U. S. NUCLEAR REGULATORY COMMISSION

Report No. 50-331/OLS-87-01(DRS)

Facility Name: Duane Arnold Energy Center

Examination Summary

Figure 2 Feedwater Control System

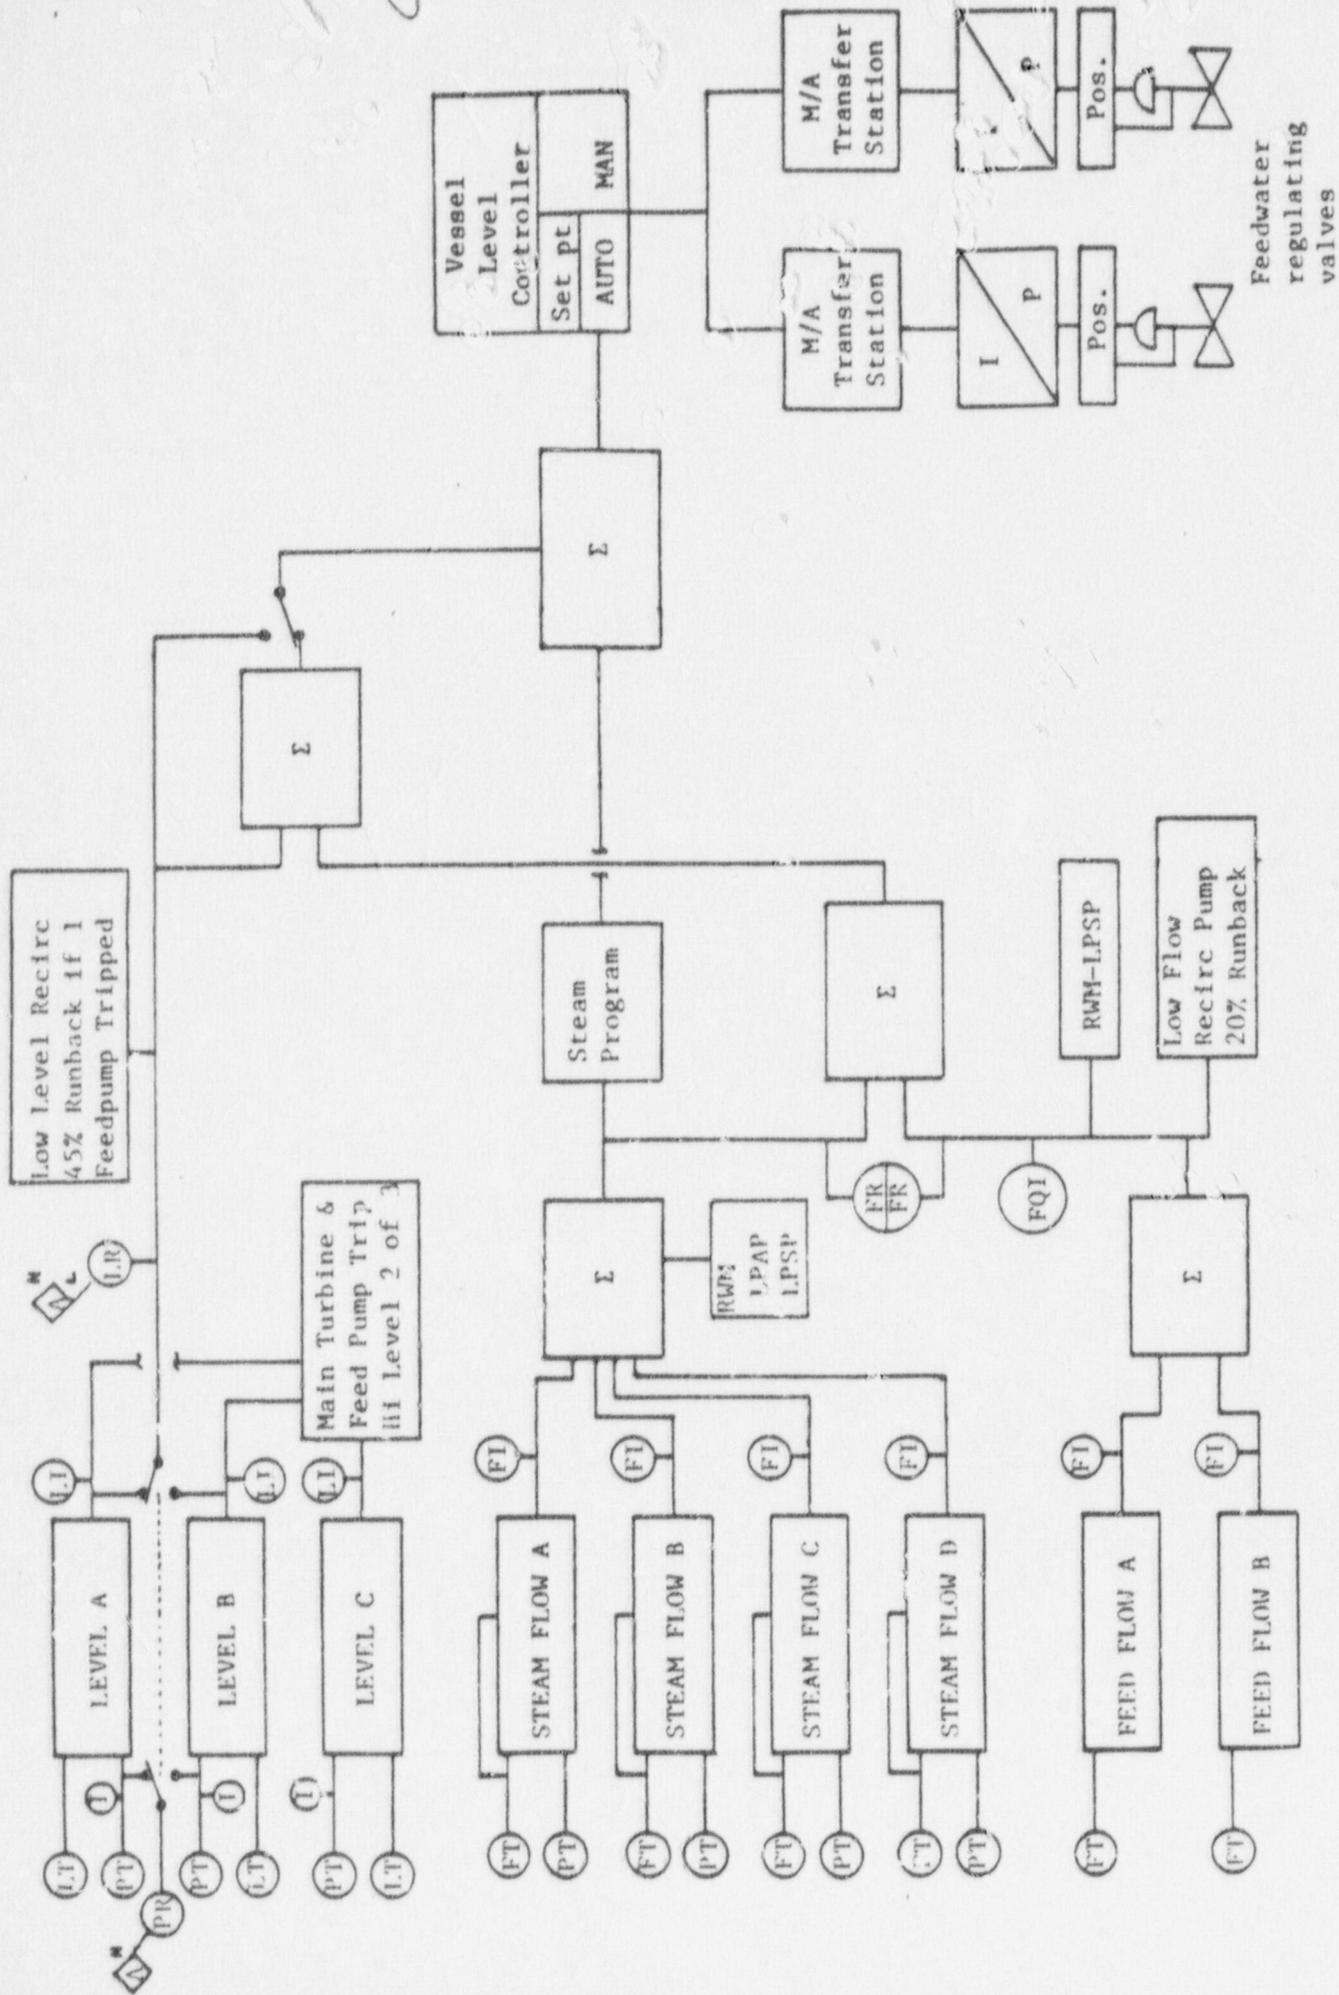
6.02 AFacility Comment:

We agree with the answer key for each condition, however, we do not feel it is absolutely necessary for the operator to answer the question using terms such as "level error, level set, steam flow/feed flow error" in order to demonstrate understanding of the feedwater control system.

We feel the format of this question could be improved by separating the questions from the initial condition statement. It is very difficult for an operator to determine the question he is being asked if the questions are all written as one sentence next to the initial condition. It is also difficult for the operator to check his answers following a lengthy exam if the questions are not readily identifiable.

The answer key for the last 0.5 points states that the "feedwater control valves will open to match new higher level." This statement is confusing and we do not agree with this answer. If the "A" level detector fails low, then the feedwater control system will see a large level error signal no matter how far level increases. Reactor level will increase until the feedwater pumps trip at 211". (See attached System Description D-15, Page 11.)

We request full credit be given if the explanation includes a final resolution of the event, i.e., "level increases until feed pump trip" because we feel this shows understanding of feedwater control.

Disagree with comment. The question asked how the reactor level will initially respond (immediately following the failure). Therefore, feedwater pump trip at 211" is the final response due to increasing reactor water level. The answer key will not be changed. The candidate need not use the exact terminology used in the answer key to receive credit. The question will be reviewed for any changes necessary to enhance clarity.
